DRAINAGE AND TRANSPORTATION INFORMATION SHEET (REV 09/2015)

RE: **Lot 26 Block 6 Unit 22 Volcano Cliffs SAD 228**
6209 Papagayo NW
Grading and Drainage Plan
Engineers Stamp Date 9/25/17 (D10D003B26)

ENGINEER'S SEAL	6209 PAPAGAYO ROAD NW	DRAWN BY WCWJ
		DATE 9-22-17
9/25/17	GRADING AND DRAINAGE PLAN	21800-LAYOUT-9-22-17
DAVID SOULE P.E. #14522	 <div>Rio Grande Engineering 1606 CENTRAL AVENUE SE SUITE 201 ALBUQUERQUE, NM 87106 (505) 872-0899</div>	SHEET # —
		JOB # 21800

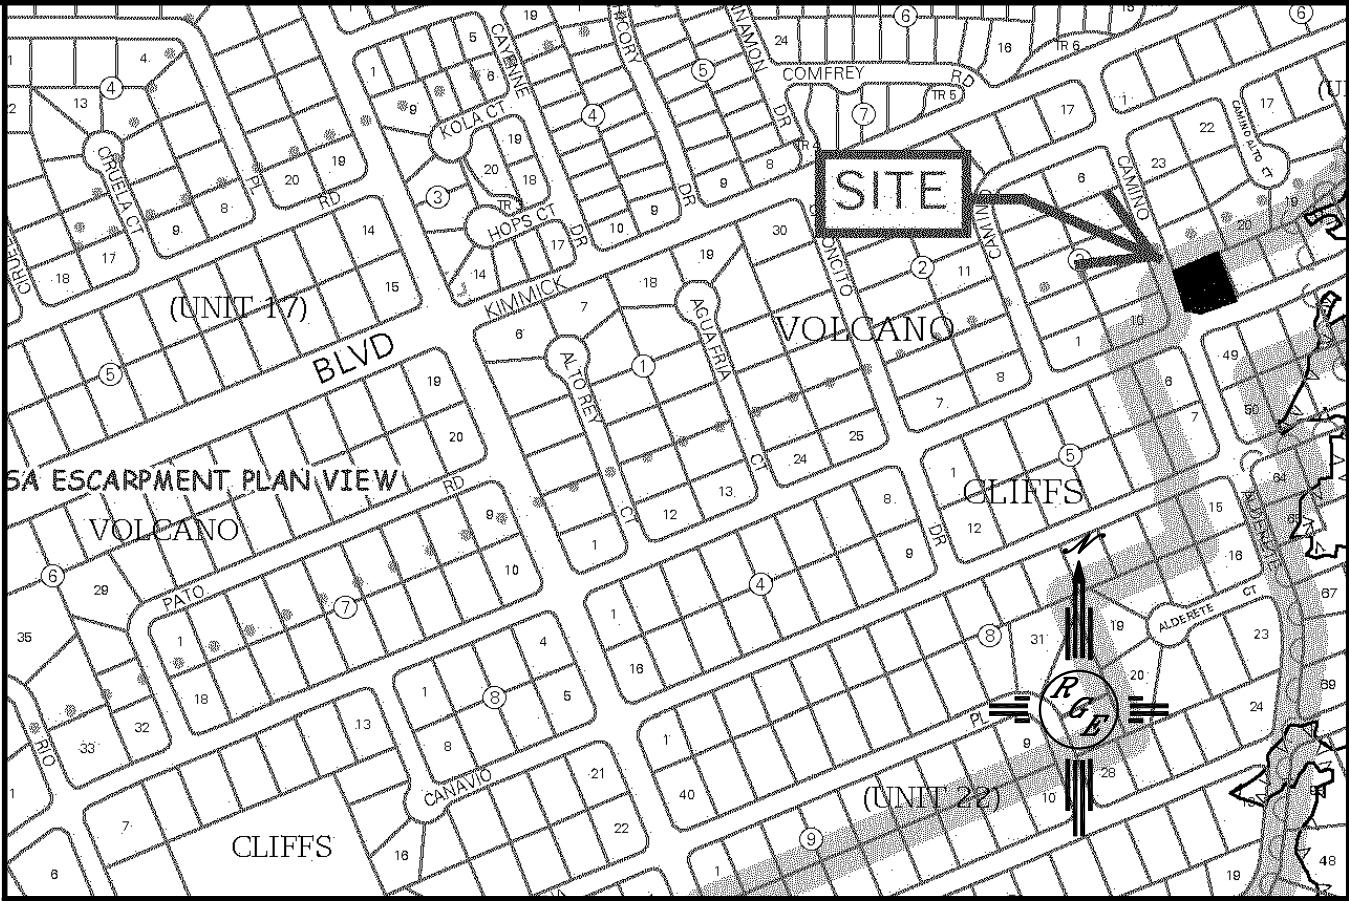
- Show the 7 foot P.U.E. in the North and East of the property. **ADDED**
- Provide size of openings and calculations required in future garden walls.
ADDED

Each opening is 6"x6"
Each block has two openings
Each opening has .52 cfs capacity
Each turned block has a 1.04 cfs capacity
